HISTORIC DISTRICT COMMISSION NOTICE OF DENIAL

Application Number: HDC2025-00753

PROJECT ADDRESS: 1616 W. Chicago Blvd Detroit, MI

HISTORIC DISTRICT: Boston-Edison

SCALE 1/4" = 1'-0"

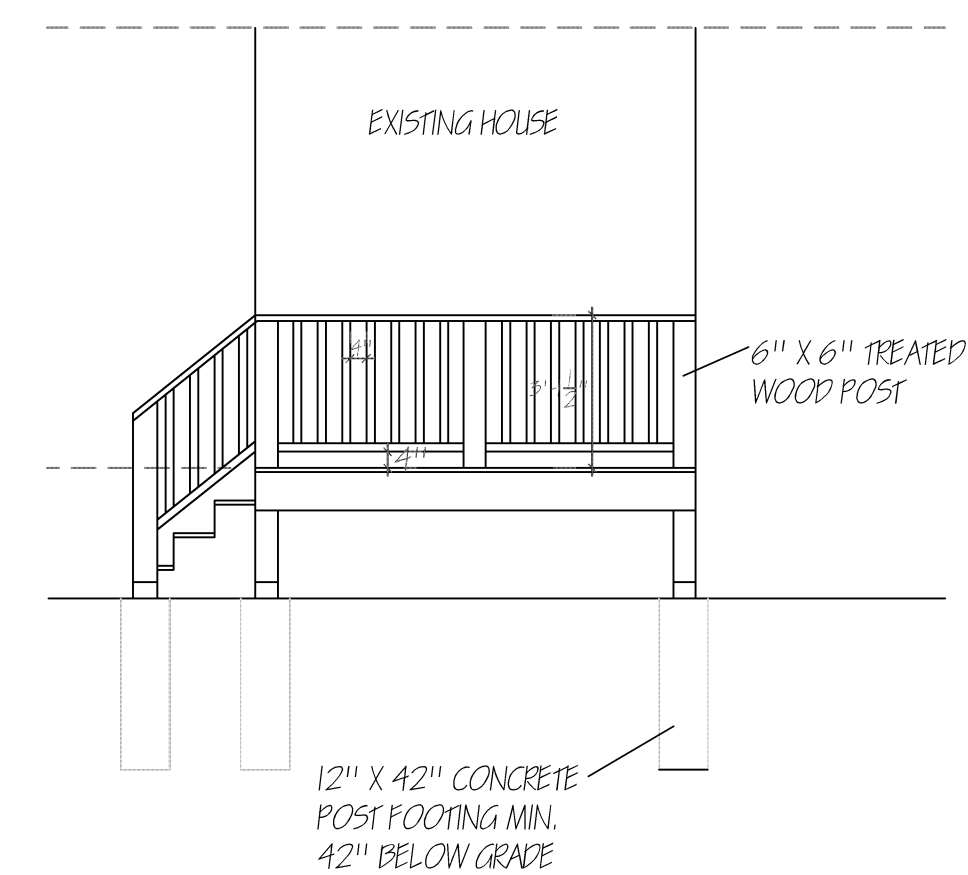
The proposed rear deck shall not extend into the footprint of the former two-story rear sunroom wing. The new design shall be submitted to staff prior to the issuance of the permit for review and approval.

REAR DECK

- Dimensioned elevation and site plan drawings with material call-outs

I have provided additional photos of the exterior of the house. We are no longer going to change any of the existing entry doors. The existing front porch slab will not be removed. We will fill in the cracks and repair the broken areas on the front of the slab. We have added a Site plan and elevations of the proposed rear deck. The site plan also shows the location of the proposed rear wood privacy fence. We will paint it within 1 year. We will not be doing anything to the dormers. I have found and attached pictures of the 2 story rear dormer before it was demolished. The siding appears to have been a stucco type covering. I'm sorry. I don't have any specifications of the siding that was on the demolished 2 story rear wing.
